## Product Notice

**Summary of issue: Dual-action pull station activation handle**

**Model numbers: All dual-action type pull stations**

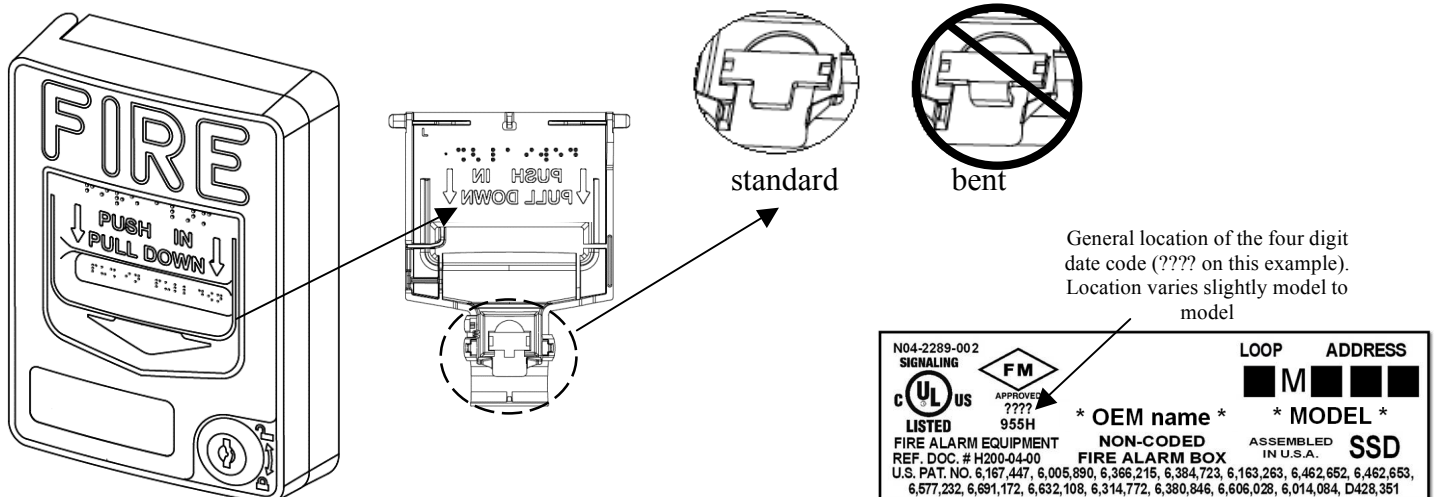
System Sensor has been made aware of the potential for an issue with certain pull stations that were manufactured at our St. Charles, Illinois facility between July 2007 and January 2010. The affected models are of the “dual-action” type. These are clearly identified by the marking on the activation handle which reads “Push In - Pull Down” as shown in the drawing below. Single action pull stations, marked “Pull Down” only, are not affected.

The activation handle on these models made use of a molded-in tab that creates the need to push the handle in before pressing downward. Some customers have reported to us that the tab can become bent in such a fashion as to inhibit movement of the handle and inhibit activation. After review and investigation, it appears that the bent tab is the result of improper installation/operation and should be apparent during normal testing and inspection per NFPA. The incident rate is extremely low and does not appear to be tied to any specific material lot or environmental condition. A design change was made to the handle component in January of 2010 that eliminated this issue.

As a part of your annual inspections and system commissioning, inspection and testing of each pull station must be conducted in the manner in which it was designed to operate and as described in the installation manual: push in and pull down on the handle. As stated in Table 14.4.2.2, section 14 (e), of the 2010 edition of NFPA 72®: “Manual fire alarm boxes shall be operated per the manufacturer’s published instructions.” This manner is consistent with operation by a typical building occupant. The pull station must not be tested in a fashion outside of the operational design. Opening the door of the pull station and manually activating the alarm switch does not meet the intent of NFPA described above. If the pull station is not tested in the proper manner, a bent tab could be overlooked.

If the pull station actuates normally and a visual inspection of the tab shows it to be straight, then the pull station does not have this issue. System Sensor will, free of charge, replace under normal warranty terms any pull station exhibiting the condition described and manufactured with a date code range of 7071 through 0011.
